**TITLE: FUSELAGE - CENTER FUSELAGE - CIRCUMFERENTIAL JOINTS AT
FRAME 45 AND 54 FATIGUE LIFE IMPROVEMENT.**

MODIFICATION No.: 52911S16337

This page transmits Revision No.04 of Service Bulletin No.A330-53-3144

SERVICE BULLETIN No.: A330-53-3144

Figure A-FSUAA - Sheet 01

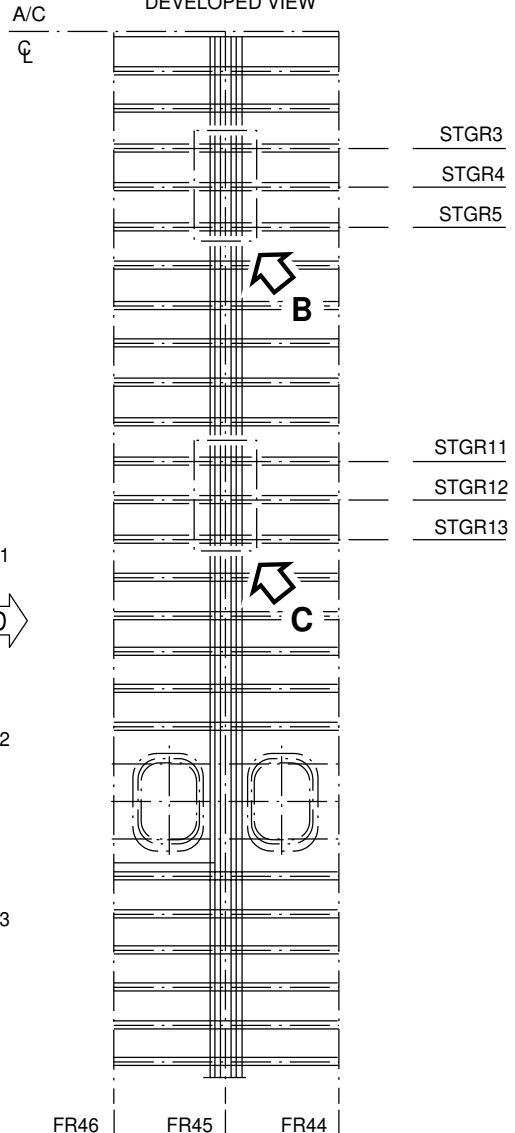
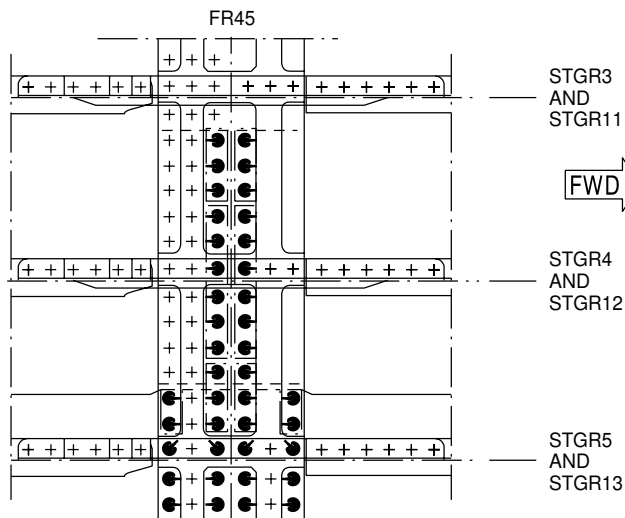
This Service Bulletin recommends oversizing to next nominal diameter and fastening with cold working and high interference fit of four fasteners rows holes between STGR3 and 5 and between STGR11 and 13 for FR45, and between STGR 4 and 5 for FR54.

REPLACEMENT OF THE FASTENERS BETWEEN
STGR3 AND STGR5 AND BETWEEN STGR11
AND STGR13 WITH COLD EXPANSION
OF THE HOLES.

Figure A-FSVAA - Sheet 01

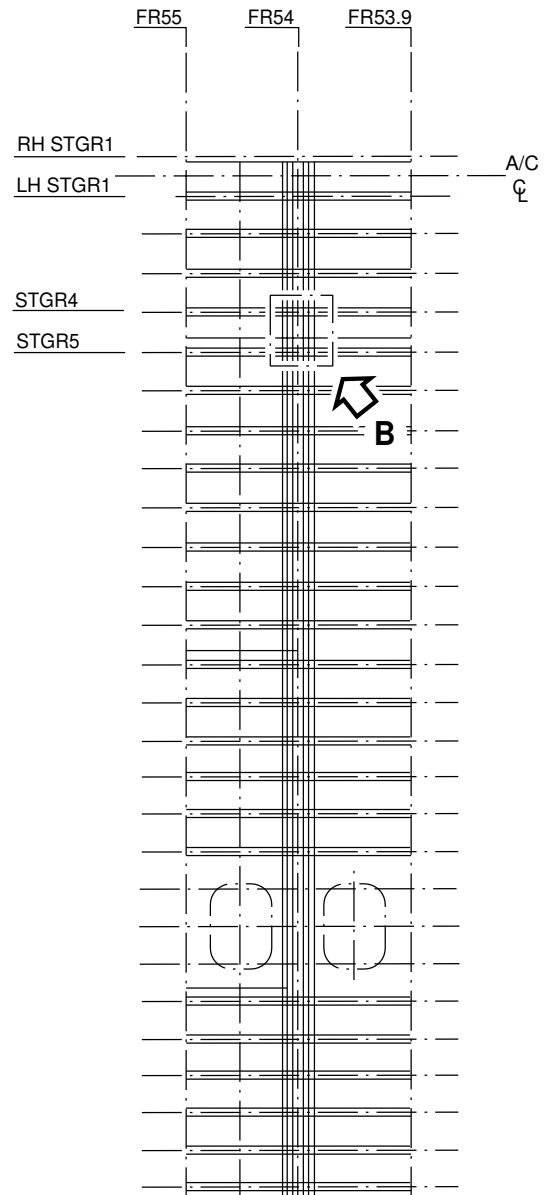
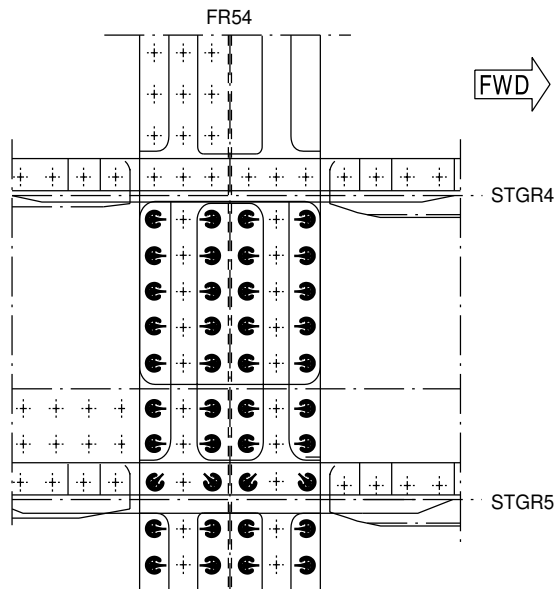
REPLACEMENT OF THE FASTENERS WITH
COLD EXPANSION OF THE HOLES.

Figure A-FBAAA - Sheet 02

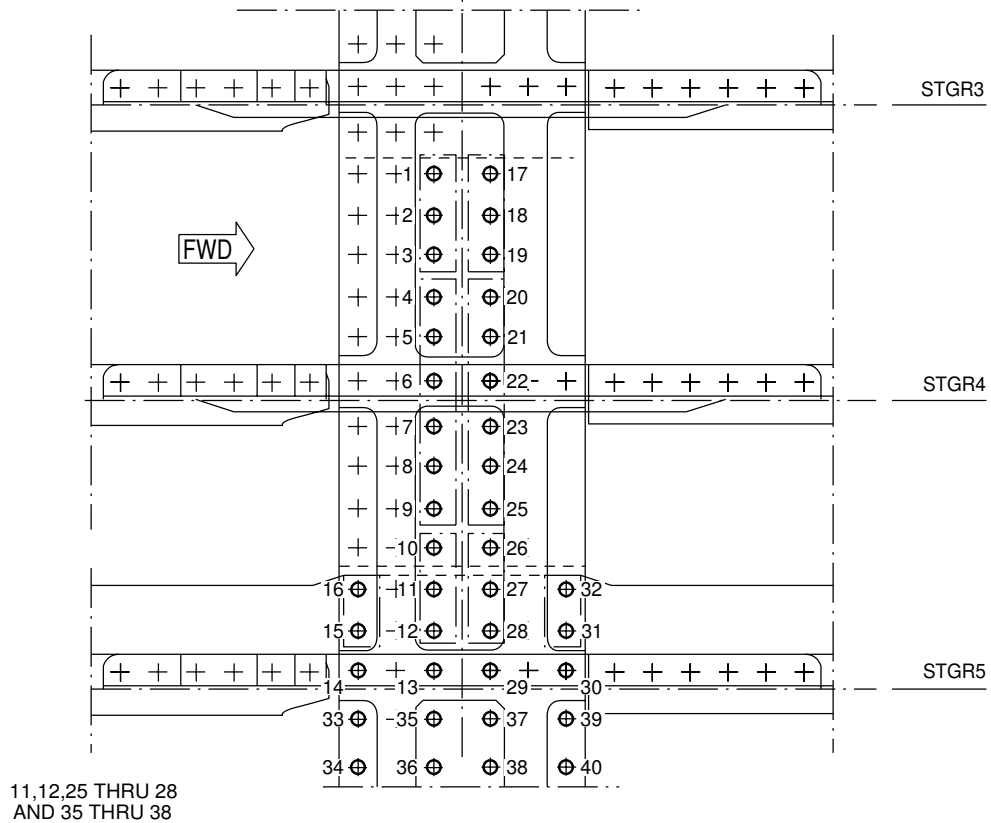
2 Do a check of the actual hole diameter and the length of the removed fasteners. Compare these with the values given in the figure [Fig. A-FBAAA Sheet 02](#). If the values are not the same, contact AIRBUS.

Figure A-FBAAA - Sheet 04
Replacement of the fasteners between STGR3 and STGR5 and between STGR11 and STGR13 on FR45.

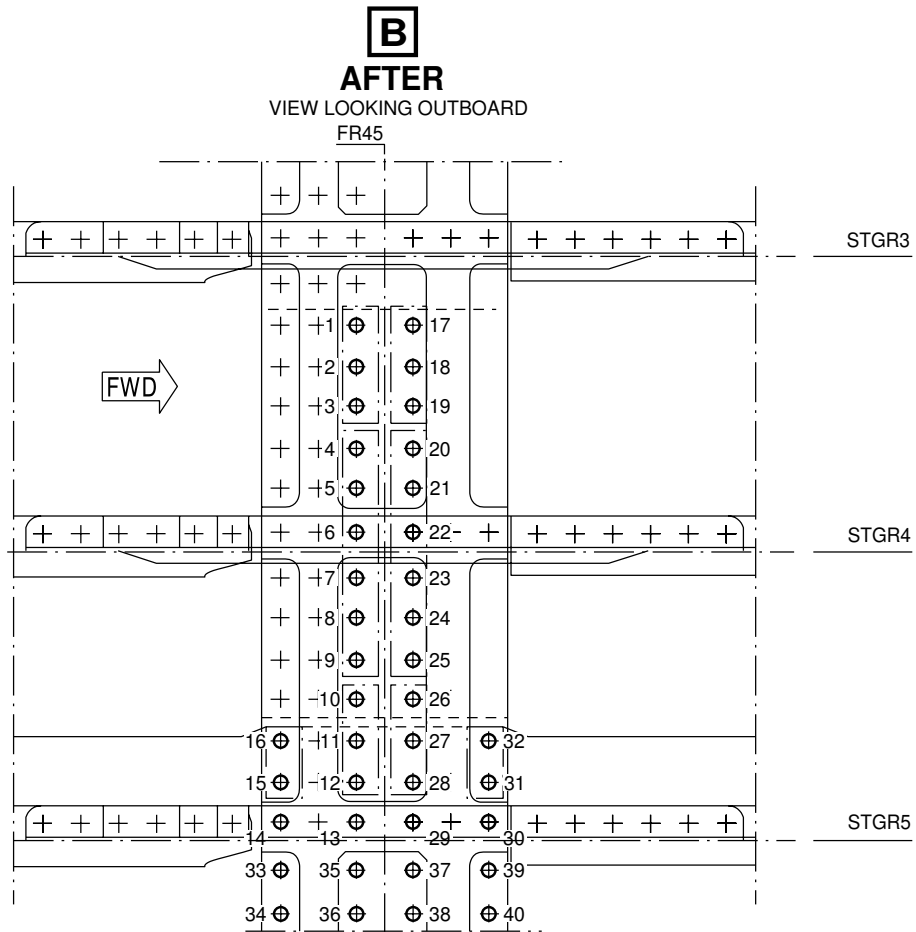
Fig. A-FBAAA		
Fig. A-FBAAA Sheet 04	SHEET UPDATED	R
Fig. A-FBAAA Sheet 07	SHEET UPDATED	R
Fig. A-FBBAA		
Fig. A-FBBAA Sheet 03	SHEET UPDATED	R
Fig. A-FBBAA Sheet 06	SHEET UPDATED	R

Figure A-FBAAA - Sheet 05

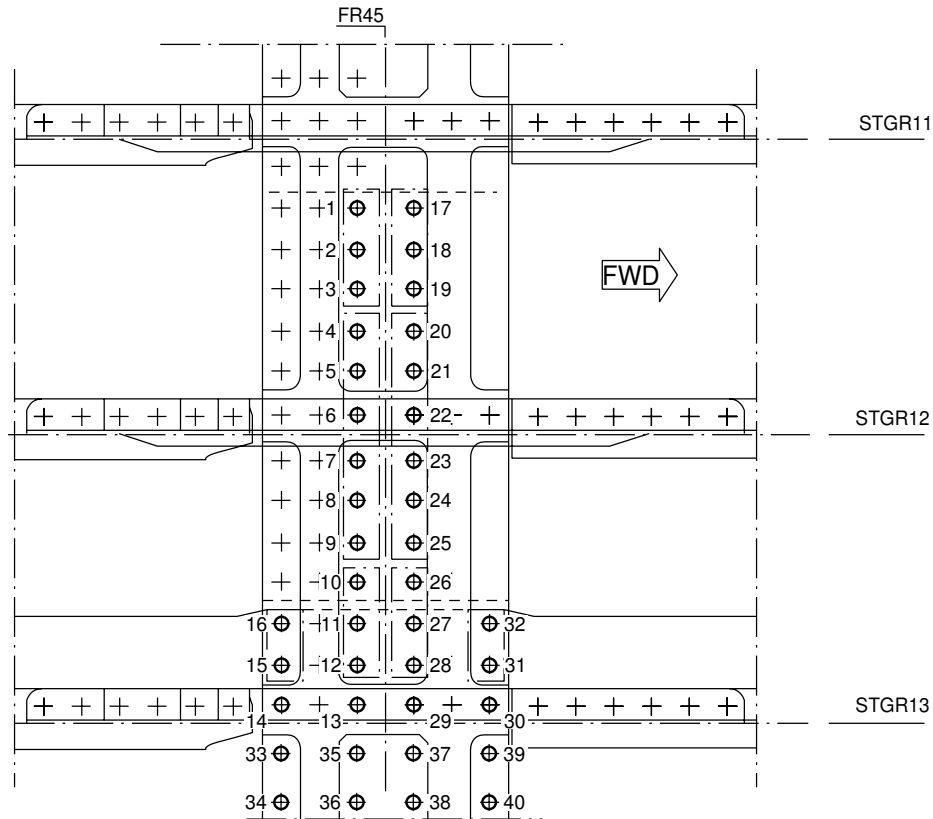
2 Do a check of the actual hole diameter and the length of the removed fasteners. Compare these with the values given in the figure [Fig. A-FBAAA Sheet 05](#). If the values are not the same, contact AIRBUS.

Figure A-FBBAA - Sheet 02
Replacement of the fasteners between STGR4 and STGR5 on FR54

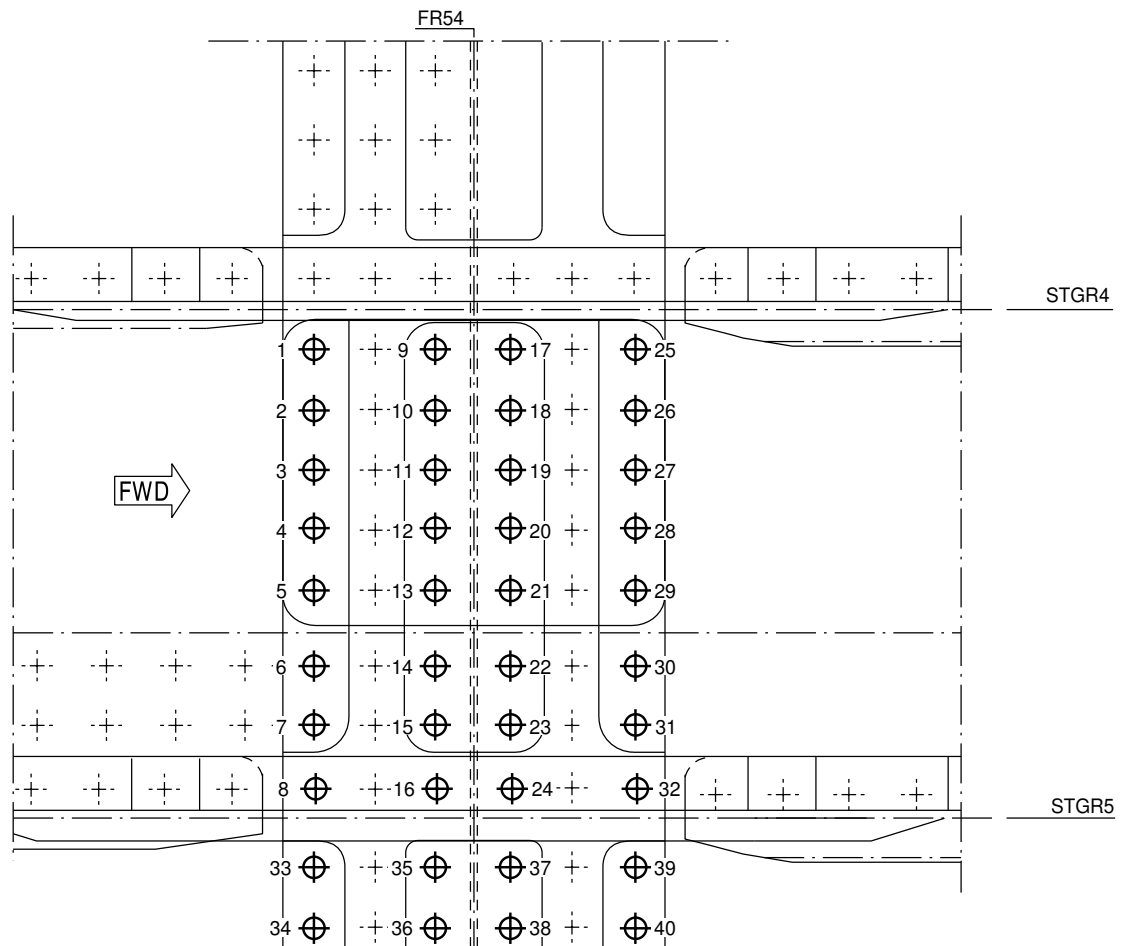
2 Do a check of the actual hole diameter and the length of the removed fasteners. Compare these with the values given in the figure [Fig. A-FBBAA Sheet 02](#). If the values are not the same, contact AIRBUS.

Figure A-FBBAA - Sheet 04
Replacement of the fasteners between STGR4 and STGR5 on FR54

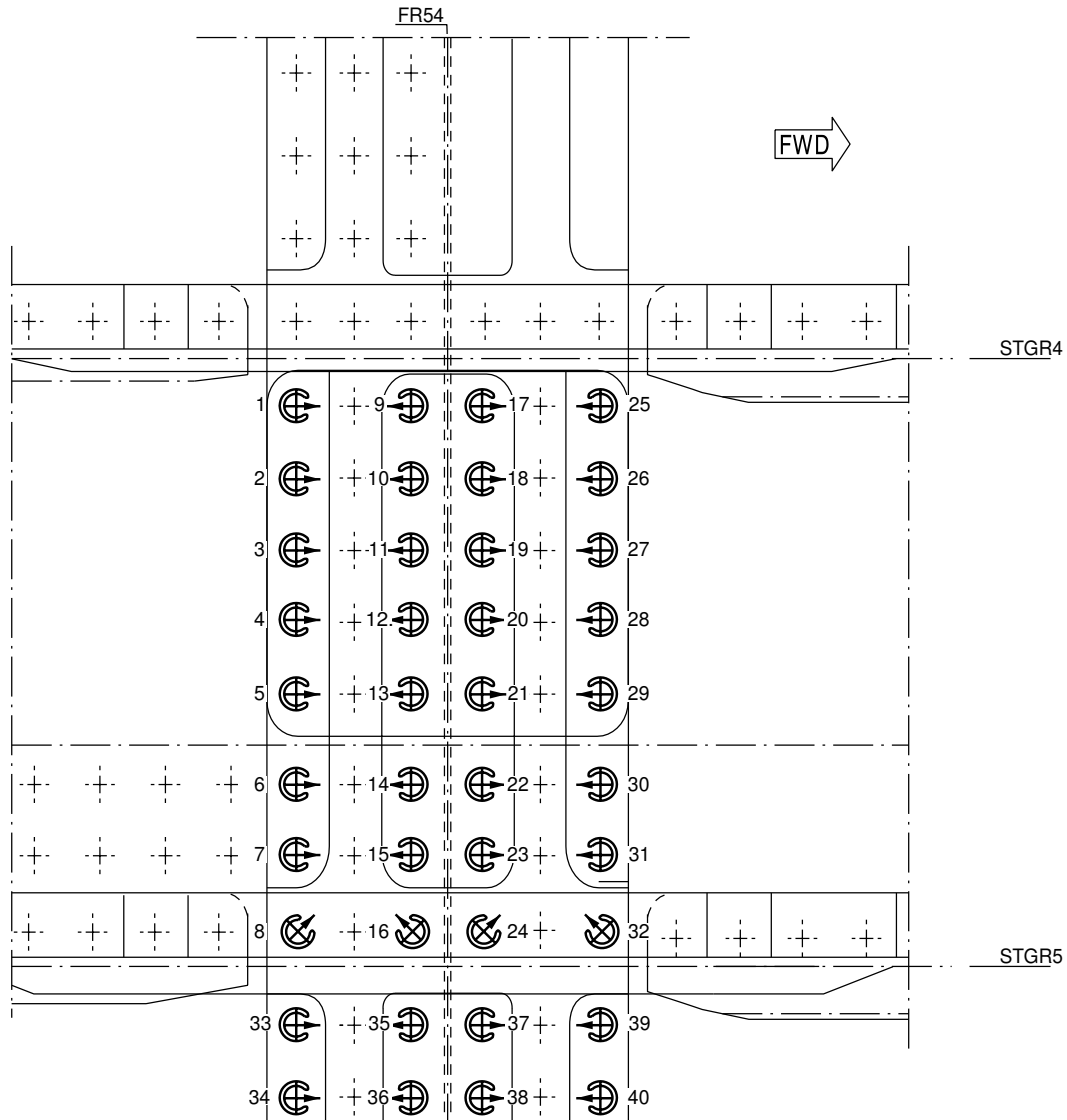
Refer to [Fig. A-FBBAA Sheet 01](#) and [Fig. A-FBBAA Sheet 04](#)
